**CERTIFICATE OF APPROPRIATENESS**

**Property:** 1409 Ashland Street, Lot 16, Tract 17A, Block 151, Houston Heights Subdivision. The property includes a historic 1,114 square foot, one-story wood frame single-family residence and a detached secondary structure situated on a 6,600 square foot (50' x 132') interior lot.

**Proposal:** Alteration – Resubmittal

EAST ELEVATION – FRONT FACING ASHLAND STREET

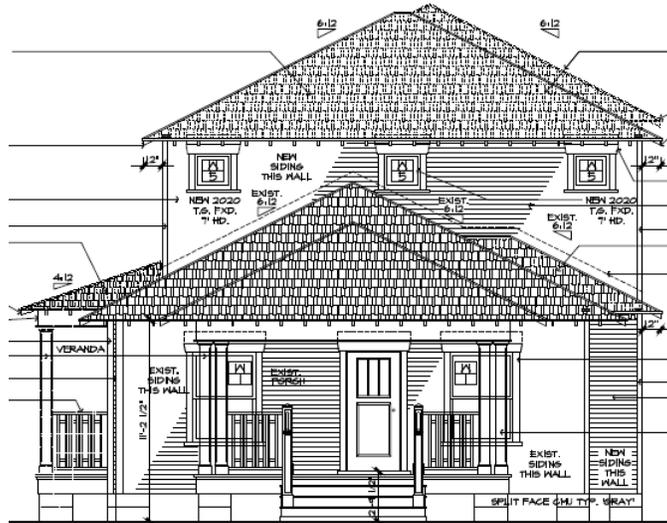
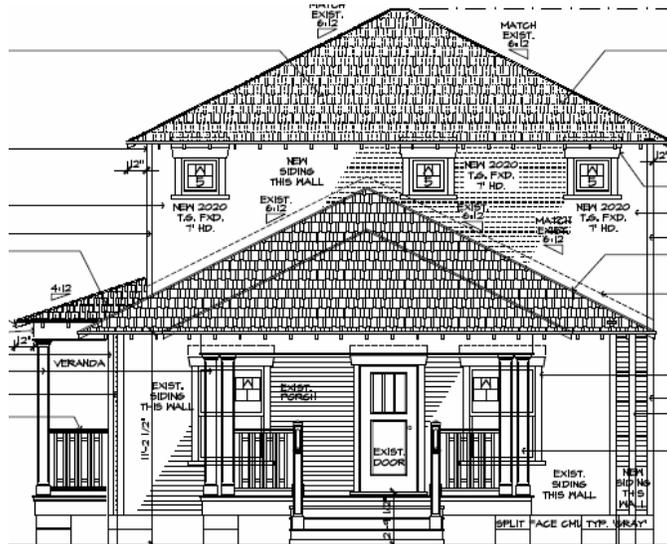
Agenda # 35 – 1409 Ashland - I OBJECT to the granting of a Certificate of Appropriateness for this property. The proposed massing volume is excessive and the resulting visual character of the property is degraded by the lack of typical volume massing found in the district.

**NORTH SIDE ELEVATION**

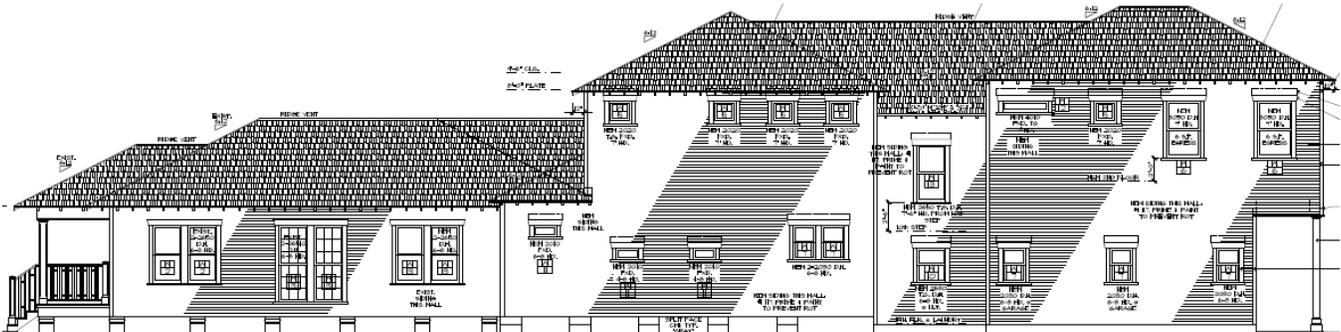
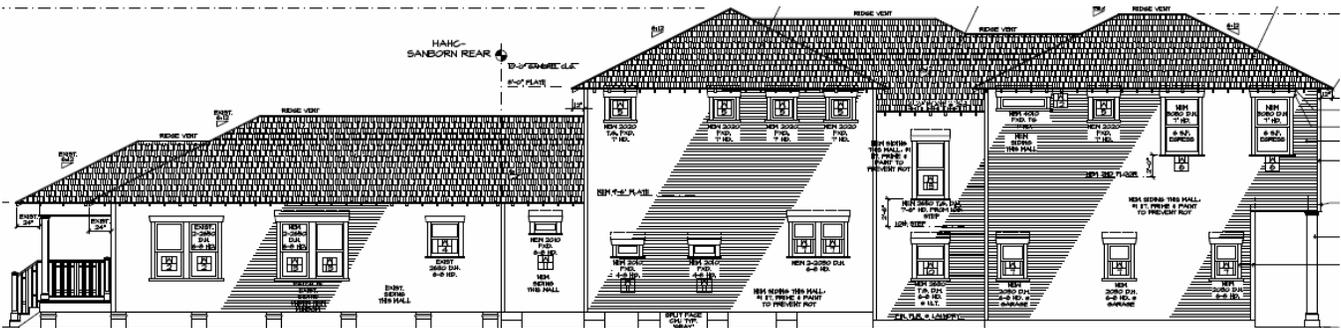
- The addition will be 2,513 square feet
- The addition's rear eave height will decrease to 21'-2"
- The addition will extend 1' wider (rather than 3') and maintain the existing roof line on the north side and will inset 1'-6" on the south side
- All existing original wood windows and siding will be retained
